Proposed Residential Development

Land North of Garden Square, Rendlesham

Addendum to Flood Risk Assessment (Ref: AMA647, May 2018)

This Addendum report has been prepared because there is a new layout for the proposed development.

Figure 10A - Non-permeable road catchments

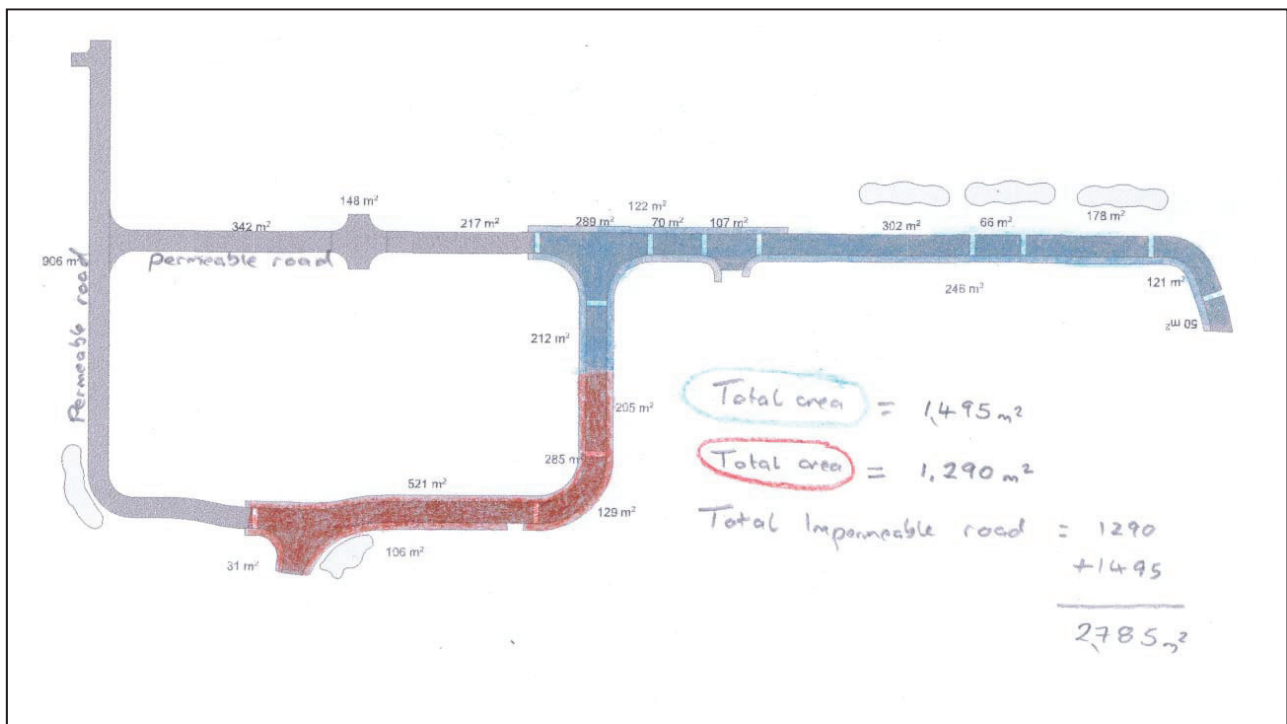
This addendum report directly supersedes section 5 of the 2018 FRA. It also includes additional comment on flood risks arising from site, specifically in relation to additional information received regarding existing flooding at Tidy Road. All other information in the 2018 FRA still remains applicable to the development/application. Unless stated otherwise, any appendices referred to can be found in the 2018 FRA. The new section 5 below is in most parts very similar to the 2018 FRA – none of the calculations have changed, just the position of swales and catchment areas. There is also a proposed change for all the roads to remain private. This is beneficial since it allows for the inclusion of more SuDS Source Control systems (in the form of further permeable road surfacing).

- 5.2.4 Figure 10A shows the highway sub-catchments established based upon site topography. The required highway swales for these catchments are summarised in Table 03A. The positions of these swales have been largely dictated by the site layout/design, but also influenced by site topography and the easements required to the public sewerage system.

- b. The key methods of runoff interception and exceedance flow routes are shown on Figure 10A. The proposed hard surfaces mainly comprise permeable paving, or fall towards swales which will intercept exceedance runoff. This is a significant improvement upon the existing situation because currently the site has no interception of greenfield runoff.

Figure A - Proposed surface water interception at south west of site

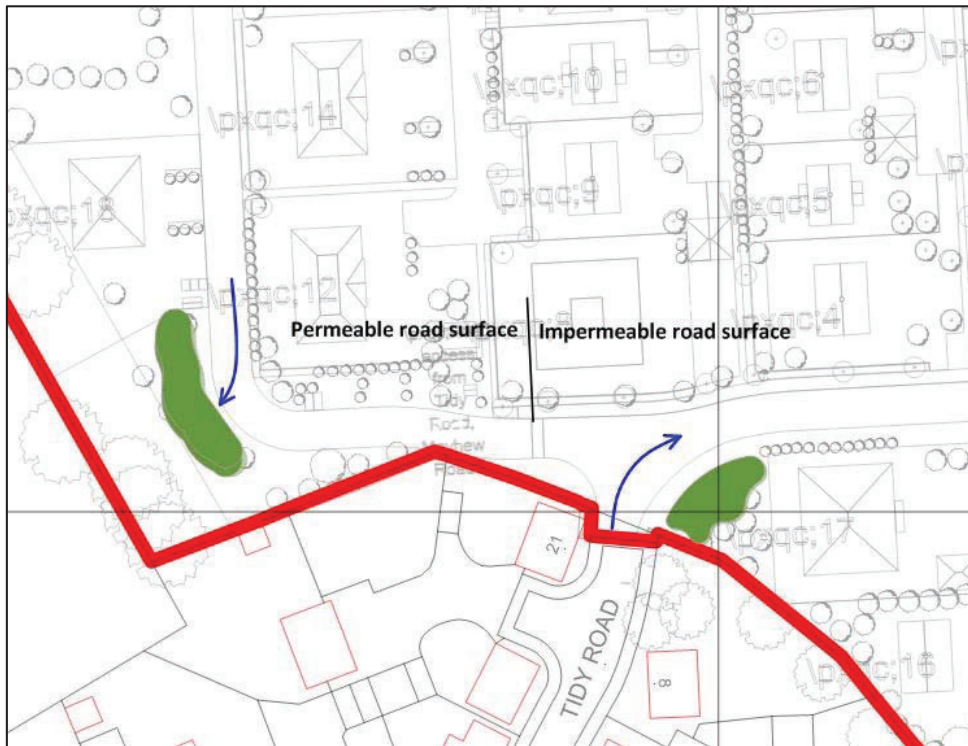
In July 2018, post issue of the 2018 FRA, we were made aware of past flooding in the garden of No 19 Tidy Road, located south west of the site. A resident has explained that there has been recurrent flooding in the garden likely to originate from the existing site field runoff.

With cohesive soils at shallow depth, some rainfall runoff will occur over the surface in the direction of the prominent topography. In any location where there is a localised 'bowl' (slightly lower ground surface) this runoff will pond at the surface and infiltrate slowly over time. This appears to be what has happened in the garden of No 19 Tidy Road. This is very often exacerbated at field corners where turning of agricultural plant creates compacted areas that further exacerbate runoff. As illustrated on FRA Figure 04, the site currently falls to the south, hence land beyond the site boundary is within the natural flow path for site runoff.

The good news is as noted in section 5.1.1 above: the proposed development includes interception and management of site rainwater runoff. So it would no longer runoff overland with no control, but be intercepted and discharge underground into the slightly deeper, permeable soil strata. The proposed permeable road surfaces will intercept runoff at source and are capable of intercepting significant rainfall from significantly rare intense rainfall events. Some of the other measures that will be put in place as part of the detailed design are shown on Figure A. The blue arrows indicate the direct of fall of the proposed hard surfaces, into the site and towards the swales that will act to intercept runoff.
